Change in running surface material

Technical Info No. 1755

Peugeot

RUVILLE no.	OE no.
56630	5751.29

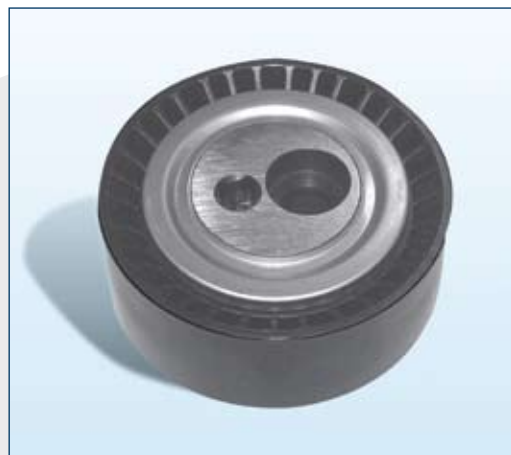
Due to the constant development of our products, the running surface of the tension pulley RUVILLE no. 56630 has been changed from metal to plastic.

The technical modification brings about a reduction in weight. Other technical properties remain unchanged.
